MFN 09-407 Docket No. 52-010

Subject: **Response to Portion of NRC Request for Additional Information Letter No. 342 Related to ESBWR Design Certification Application ESBWR RAI Number 19.2-127**

RAI Number 19.2-127

Question Summary: Provide an analysis of the effects of erosion of sacrificial concrete.

Figure 1: PCCS Heat Removal without BiMAC CCI

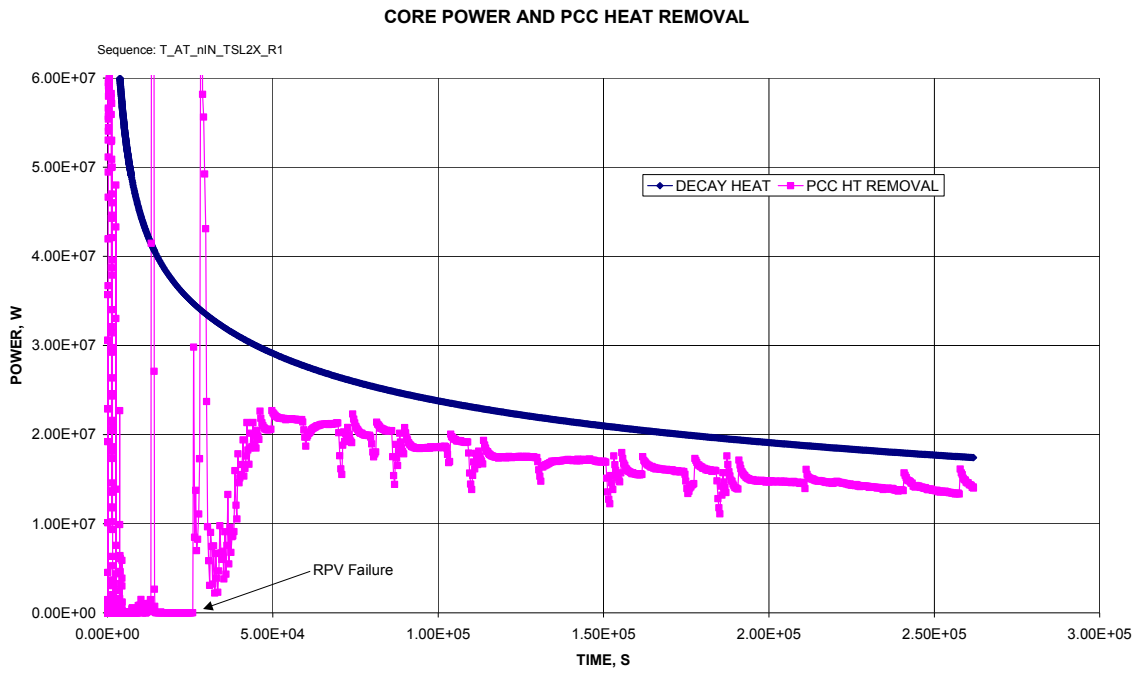
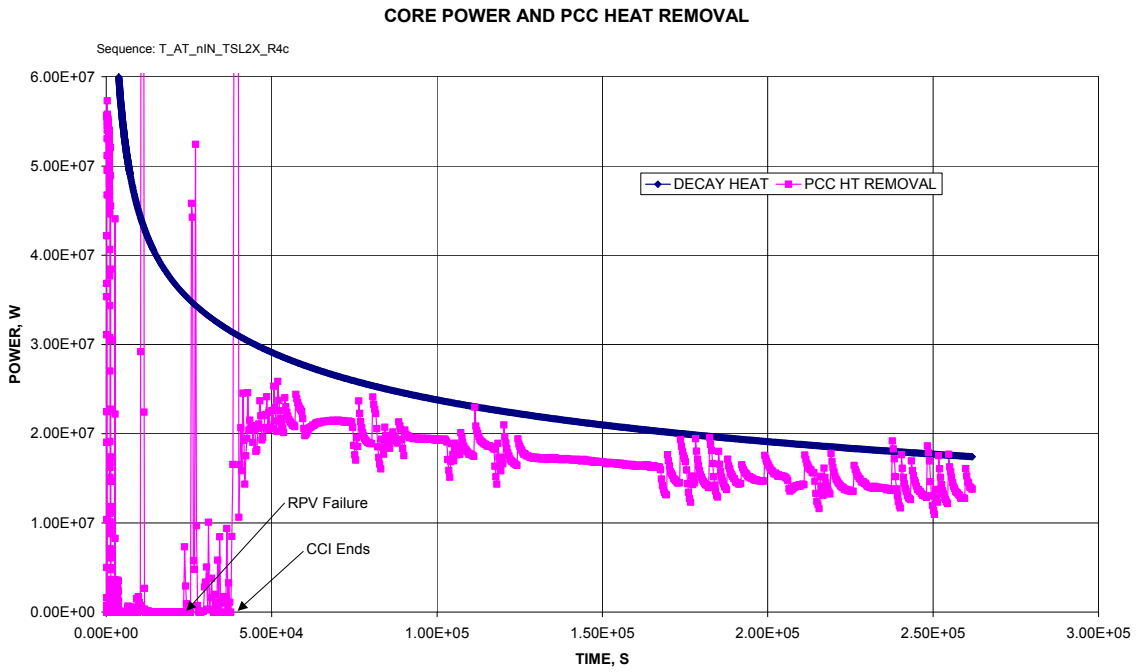
The NRC staff discovered that a change had been made by GEH in the type of material on the lower drywell floor that would lie above the Basemat Internal Melt Arrest and Coolability (BIMAC). Instead of zirconia, a concrete sacrificial layer would be used. Please provide an analysis of the effects of erosion of the sacrificial concrete above the BIMAC on containment integrity during representative severe accident scenarios. The analyses need to consider the following:

- *the effects of gases and fission product aerosols produced from the core debris/concrete interactions (CCI) on PCCS performance and pressure increases in the containment regions;*
- *ranges of potential containment failure times for the representative scenarios;*
- *any changes to the release category frequencies and the large release frequency (LRF), relative to those reported in Revision 3 of the ESBWR PRA;*

Case 15 is the representative sequence for successful operation of containment heat removal by PCCS. A comparison of PCCS heat removal in Case 15 as analyzed for PRA Section 9 Revision 4 to this analysis is shown in Figures 1 and 2 below. These figures show that the assumption of CCI depresses PCCS heat removal until cooling of the corium is allowed. This is an expected result due to the reduction of heat transfer from corium to the overlying pool required for CCI results in less steam being produced. The condensation of steam is the main heat removal mechanism for the PCCS.

The long term pressure in containment increases from approximately 0.54 MPa gage (78 psig) in the base case to approximately 0.76 MPa gage (110 psig) when including CCI due to the additional non-condensable gases in containment. These pressures are below the limiting containment failure pressure in DCD App 19C Table 19C-13 [Reference 3]. The limiting 95% confidence value at a containment temperature of 533 K (500°F) is 1.095MPa gage (158.8 psig).
